CABIN JOHN PARK SEC. 1 (120051030 FORMERLY 1-05103)

PRELIMINARY SUBDIVISION PLAN
CABIN JOHN PARK, SECTION 1
BEING A RESUBDIVISION OF LOT 56A
PROPOSED LOTS 221 AND 222
ELECTION DISTRICT NO. 7
MONTGOMERY COUNTY, MARYLAND

RE: Cabin John Park, Section 1
Resubdivision of Lot 56A
Preliminary Plan No. 1-05103

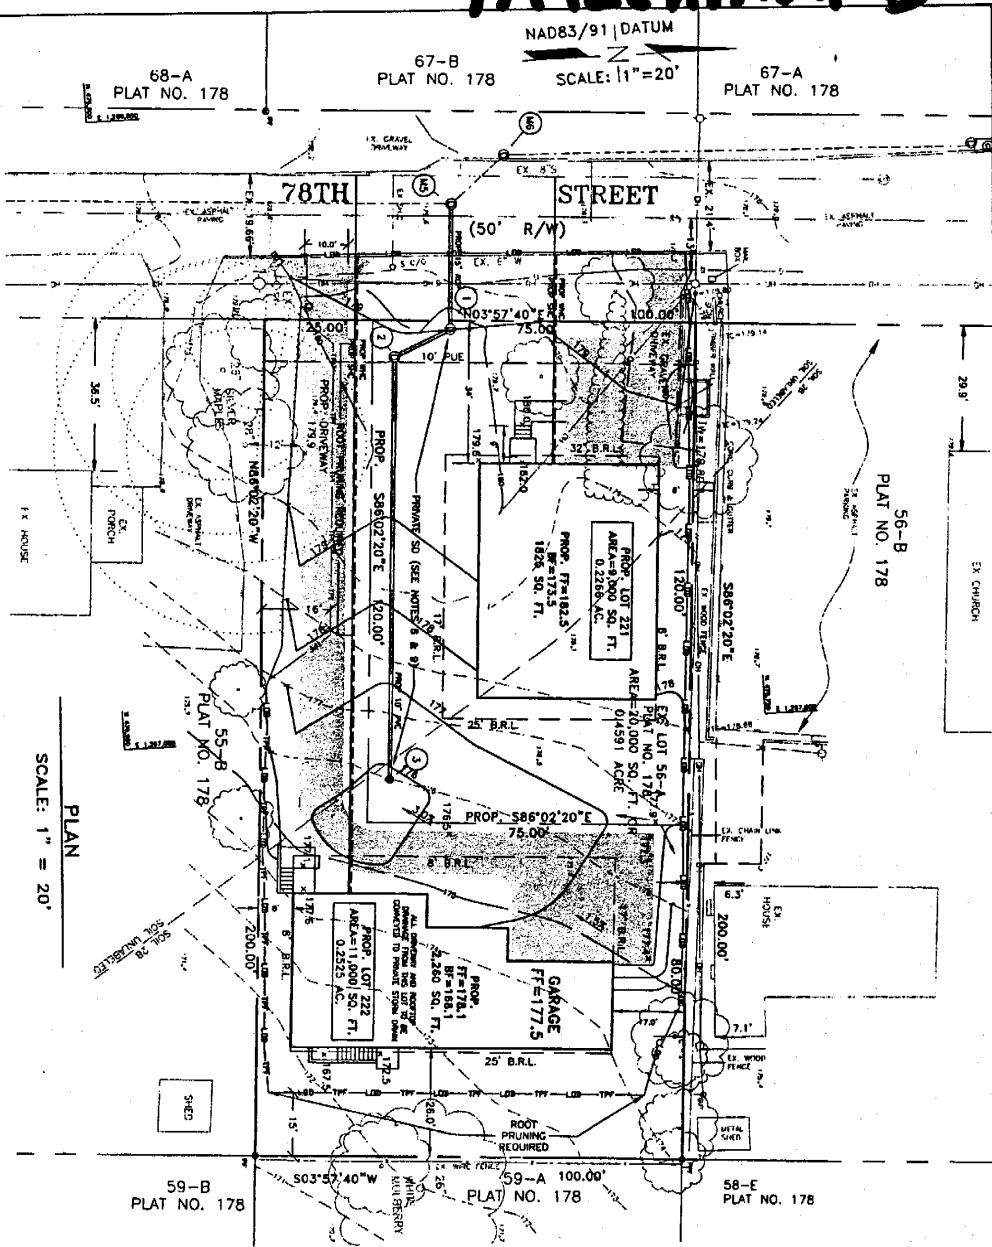
The Plan for resubdivision, we believe, would result in significant property damage due to increased runoff. To accommodate two homes, as the Plan proposes, significant changes in topography have been proposed. The lack of land to absorb the natural drainage of rainfall would be acute.

Under current Zoning, a home may have no more than a 30 percent footprint on these lots. Based on the engineering plan as submitted, we believe that the two proposed homes combined with long driveways could cover at least half of existing lot 56A.

With the topographical changes, the homes would act as dams, the driveways (especially of proposed Lot 222) would act as funnel swales, and the water could be expected to flow heavily

For example, at great expense to the County a storm drain modernization project was just completed on 78th Street due to a unique environmental (i.e., water drainage) concern in the vicinity of Lot 67-B (also known as 6518 78th Street). The proposed Plan would add two driveways into 78th street, one of these being nearly 200 feet long in l-shaped length This driveway for Proposed Lot 222

would not spill into 78th Street at a point that would allow capture of the runoff by the new storm drain system. Indeed, the topography suggests that this driveway would flow downgrade towards the water easement. To raise the topography and to at least partially address the drainage issues would create a problem to replace the one solved on 78th Street.

Per Mr. Dunn's findings, we have shifted the location of the proposed driveway farther from the common lot line. The now proposed driveway will be 12 feet from the nearest tree to the common lot line (the 28" silver maple) -- a distance of over 5 diameters from the root base at the ground line. Please see the revised plan. We will employ the recommended tree root pruning and protective fencing per Mr. Dunn's advice.

Further, as shown on our Stormwater Management Concept Plan (which has been approved by MCDPS), we would direct stormwater from the driveway toward the front of the property – filter it across a lawn – and then direct any remaining excess flow into a storm drain. This approach will eliminate shedding storm water from newly introduced impervious surfaces to the rear of the lot, which is low and currently wet during storms due to runoff from our and surrounding lots. Indeed, the proposed situation will affect a reduction in the amount of stormwater that currently reaches the back of the property in its unimproved condition.

Far from being dismissive of related concerns, however, we affirmatively addressed them in our planning for our lots and in the program submitted for approval. Indeed, our program will not contribute additional runoff to the rear of the lot – but it will decrease existing stormwater drainage there to 25% of the existing condition (see attached calculation). The program improves the existing stormwater concern. As noted, the proposed program was approved by MCDPS in its approval of the Stormwater Management Concept Plan, and we have no negative comments from other impacted agencies.

There is no water or drainage easement of record that we could find. Nonetheless, our program would not change the grade at the rear for the lot within approximately 25 feet of the rear property line. It would not interfere with existing drainage patterns for surrounding properties.

Our plan would sensitively shed both existing and planned stormwater runoff from the rear of the property toward 78th Street (away from the rear of the lot), thus actually substantially reducing runoff. This has been accomplished by careful siting of proposed houses and modest regrading (a maximum change of less than 3 feet at the front of the proposed house on the rear lot) and by installation of a storm drain. The topography over the majority of the site would remain unchanged and, where changed, is generally within a foot or so of existing conditions.

Although no Site Plan approval is required for this resubdivision, the development illustrated on the Preliminary Plan proposes building coverage of 20.5% and 20.3%, both well under the 30% allowance of the Zoning Code. The Applicant would expect that as architectural plans evolve, building footprints would actually be less.
